Addendum to IFB

IFB NUMBER: IFB 22-074/JW
IFB TITLE: Mesquite Point Public Boat Ramp
IFB DUE BY: 11:00 am CT, Friday, January 6, 2023
ADDENDUM NO.: 2
ISSUED (DATE): December 28, 2022

Reason for Issuance of this Addendum: Clarifications (See PAGE 2-3, Attachment 1)

BRIDGE LAYOUT
SABINE LAKE

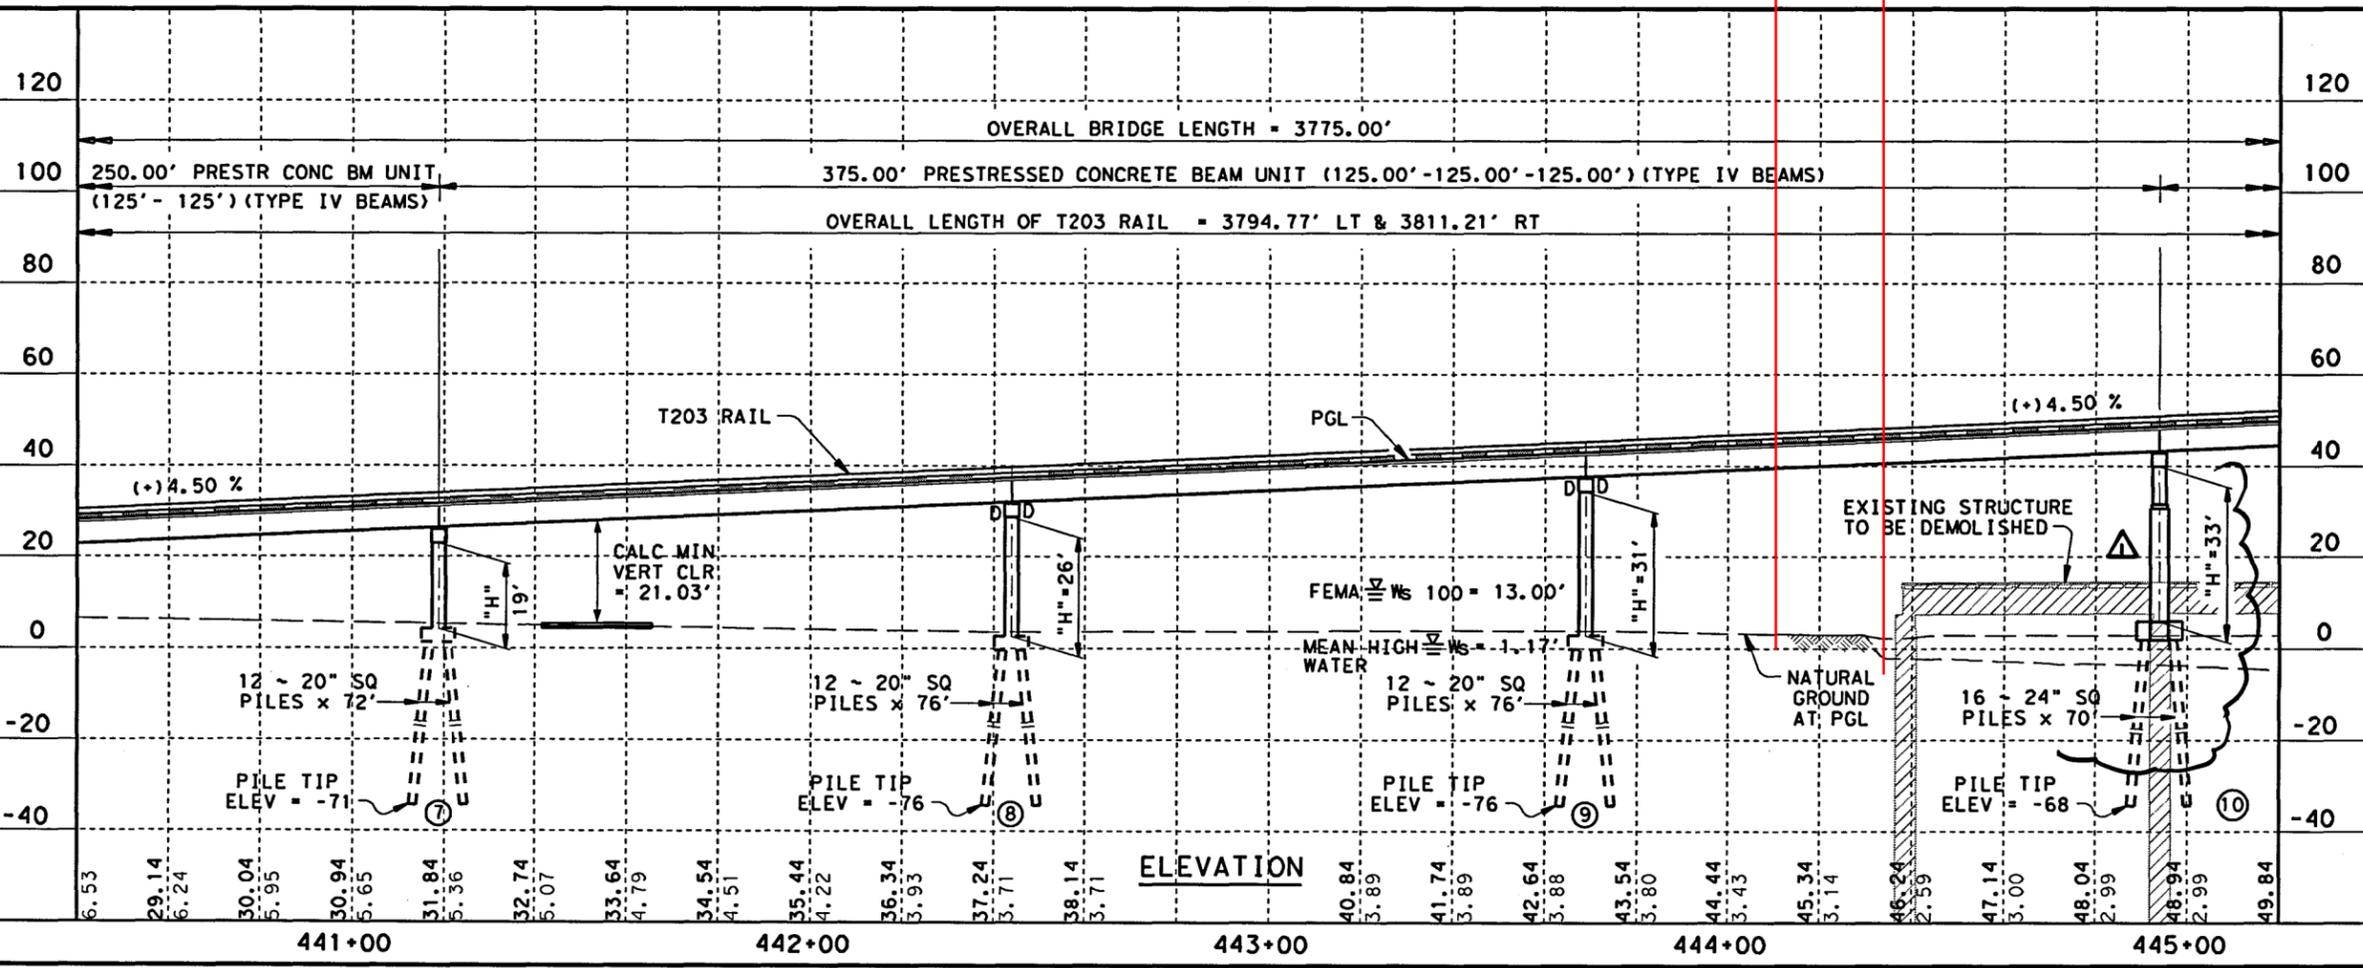
NOTE: THE "H" VALUES SHOWN ARE ESTIMATED COLUMN HEIGHTS. THE CONTRACTOR IS RESPONSIBLE FOR CALCULATING THE ACTUAL COLUMN HEIGHTS BASED ON FIELD CONDITIONS.
